Office Action Summary

10/604,008

This is the first Office Action for application number 10/604,008, Gas Cylinder Base, filed on 6/20/03. Claims 1-32 are pending. This application claims priority to provisional application 60/398,202 dated 7/24/02.

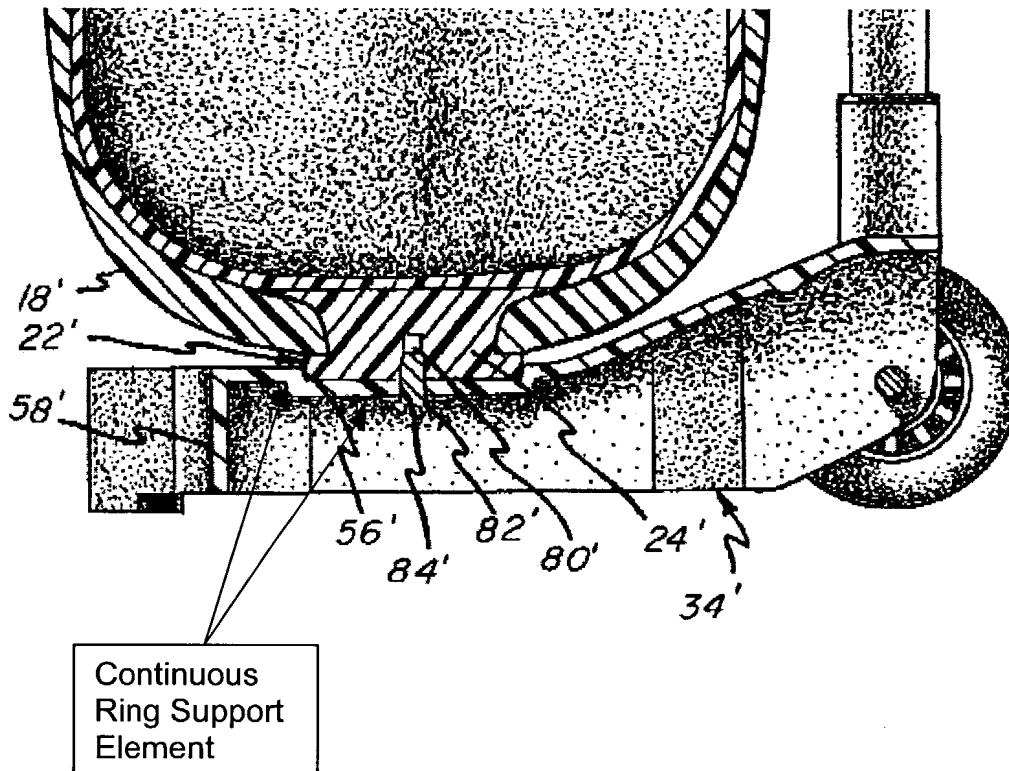
Claims 1-5, 7-10, 17-21 and 23-26 are rejected under 35 U.S.C. 102(b) as being anticipated by United States Patent No. 6508477 to Burkett to the embodiment shown by Figs. 6-9.

The patent to Burkett discloses a gas cylinder (14'), the cylinder having a base ring (22', 24') with a threaded aperture therethrough (80'), the base having a base skirt (42'), having a first lateral dimension, which is greater than the diameter of the cylinder (14') and a continuous ring support element (See Drawing Below), the support element which extends upwardly from the base skirt and which defines a second lateral dimension less than the first lateral dimension and a threaded fastener (82') inserted in a threaded aperture (84') therethrough in the support element and in the threaded aperture (80') of the base ring (22' 24') of the cylinder, for attaching the gas cylinder to the base by engaging the base ring of the cylinder, the fastener (82') having a point at an end which engages the base ring (22', 24').
